## ADDENDUM NO. 2

Request for Proposal Call No. RFP2024-418  
**CONSTRUCTION OF THE FIELD HOCKEY & MULTISPORT TRAINING DOME,  
COMFORT STATION AT THE CASSIE CAMPBELL COMMUNITY CENTRE**

This Addendum forms part of the Bid/Proposal Document.

**1 AS3 PROFILE INSTALLATION DETAIL (TYPE 'B') NOT TO SCALE**

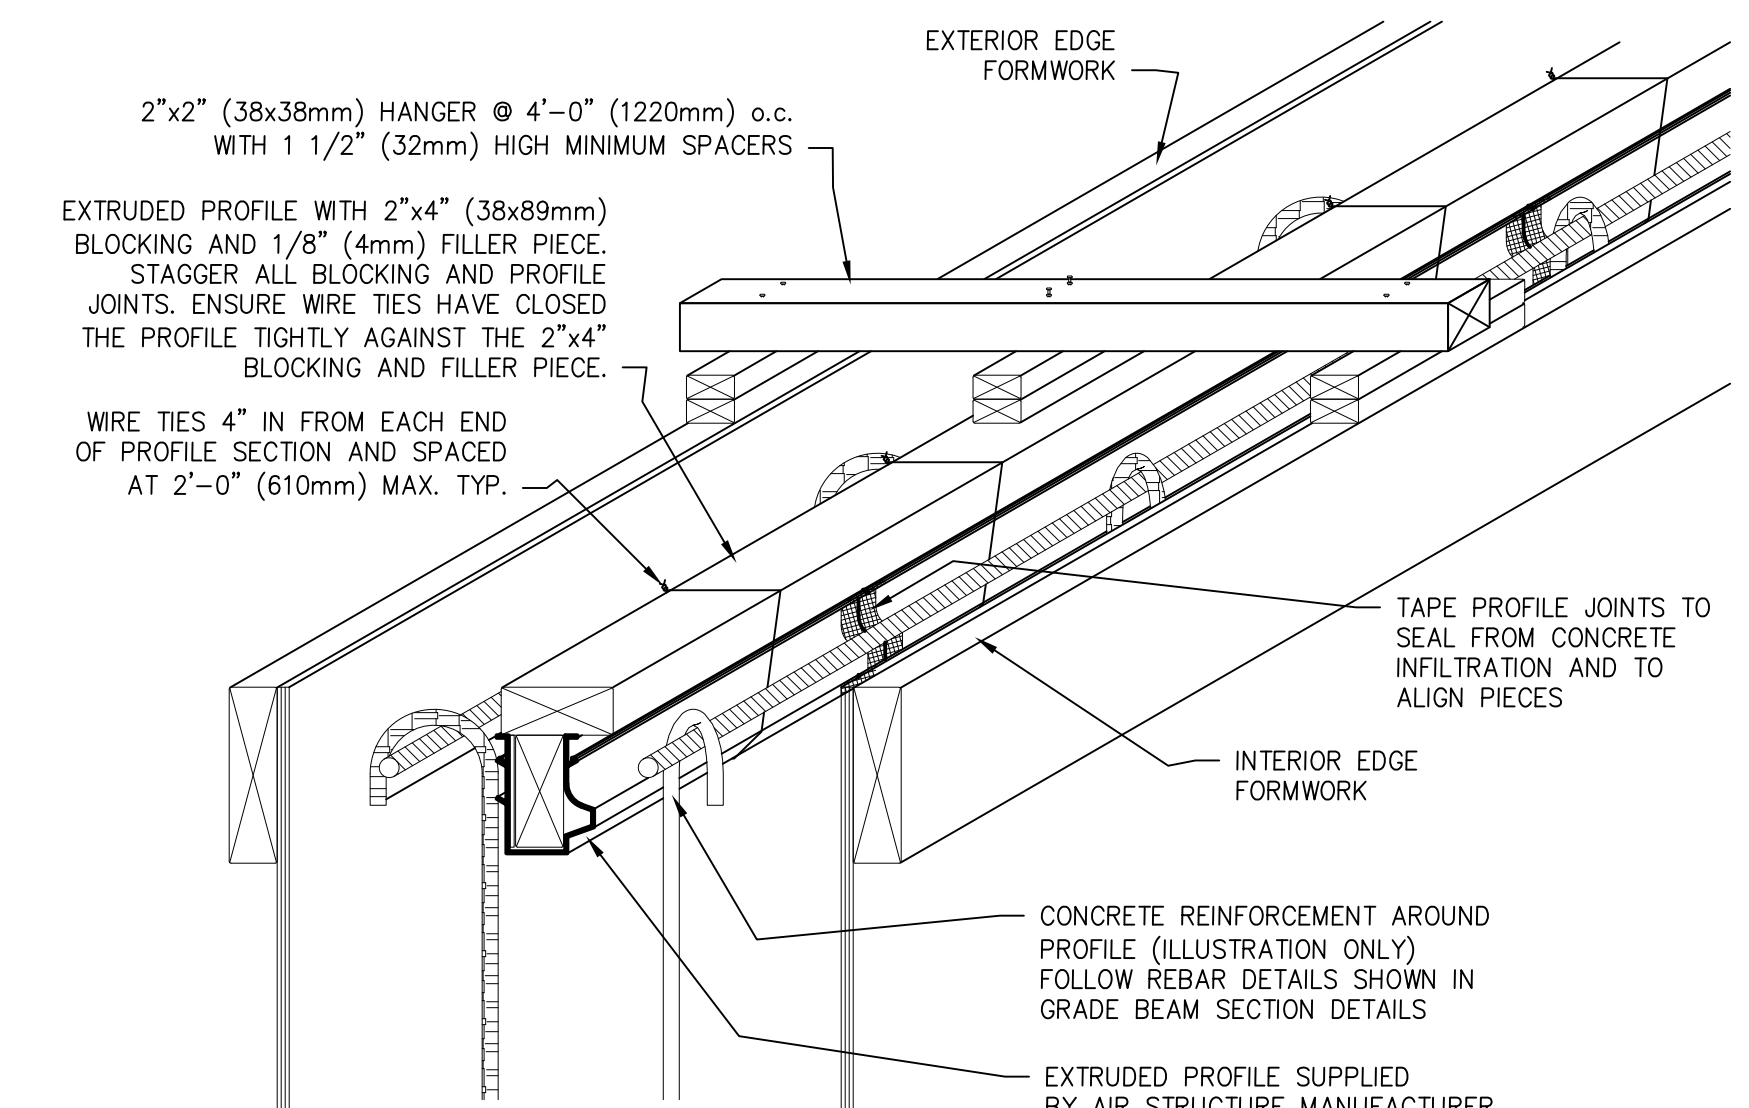
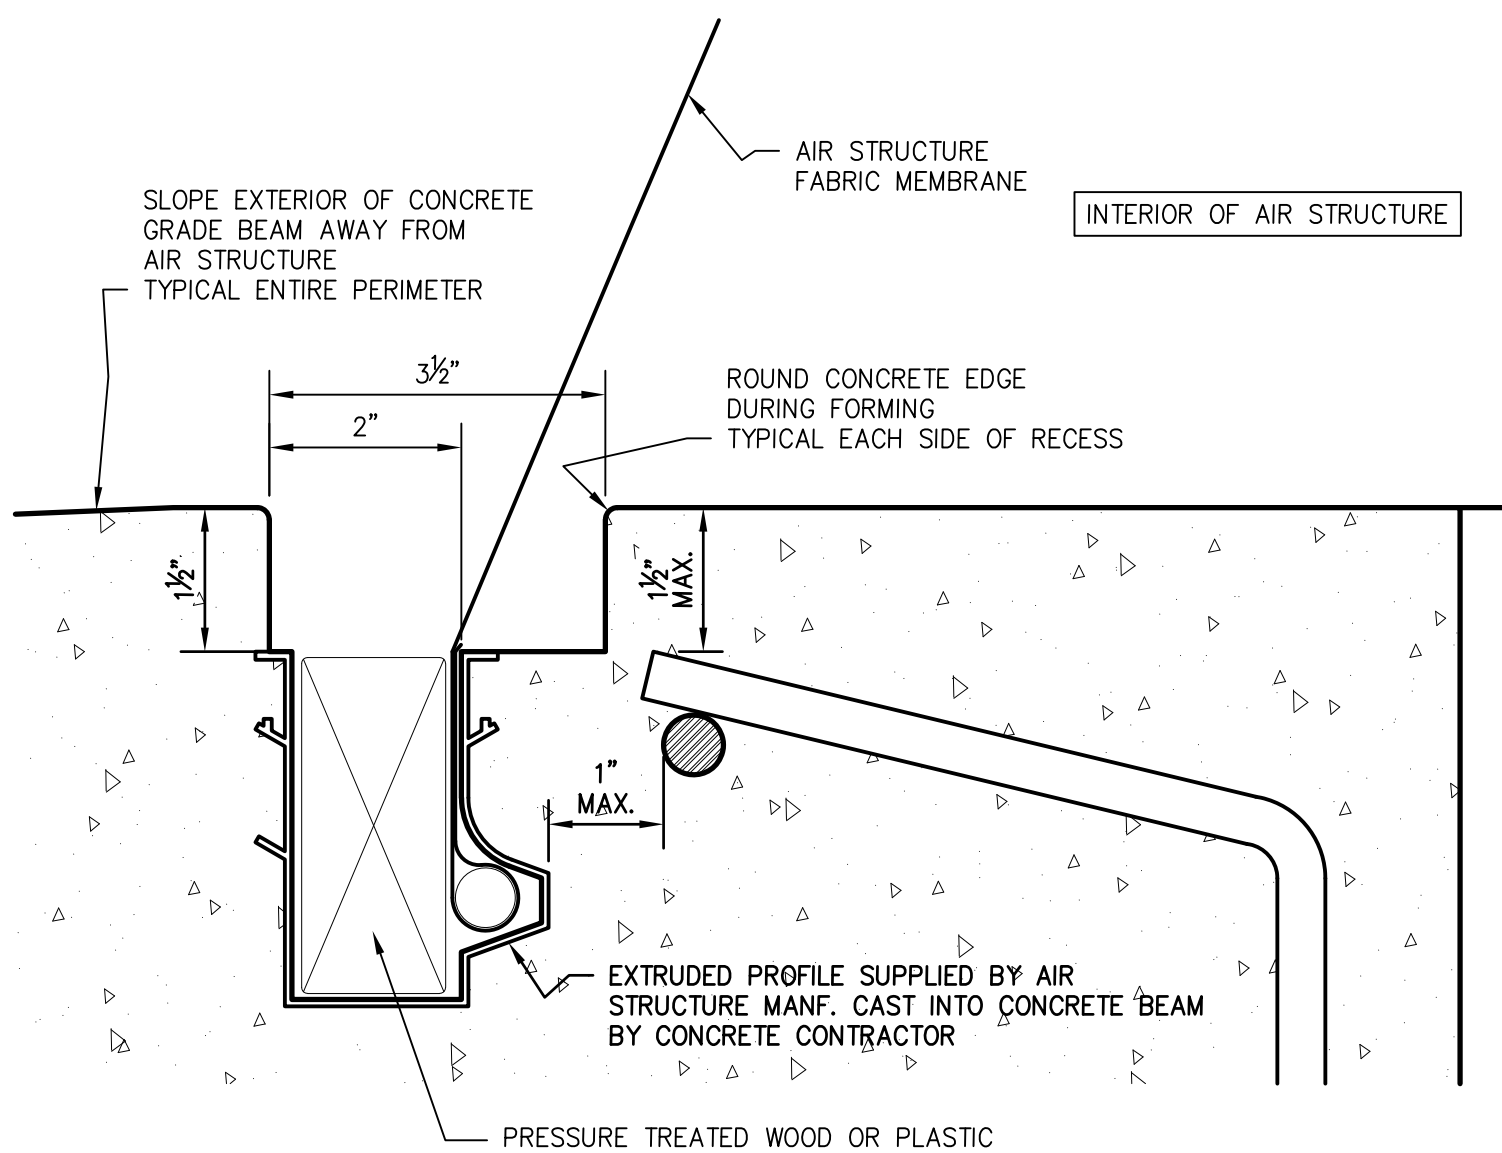
**Q19: Burnside Drawing AS3- Is there a step detail for the concrete footing showing the transition from 112" to 64" depth?**

A19: Refer to attached detail titled, Response to Question 19 Drawing AS – 3.  
(Total sheet of Drawing 1)
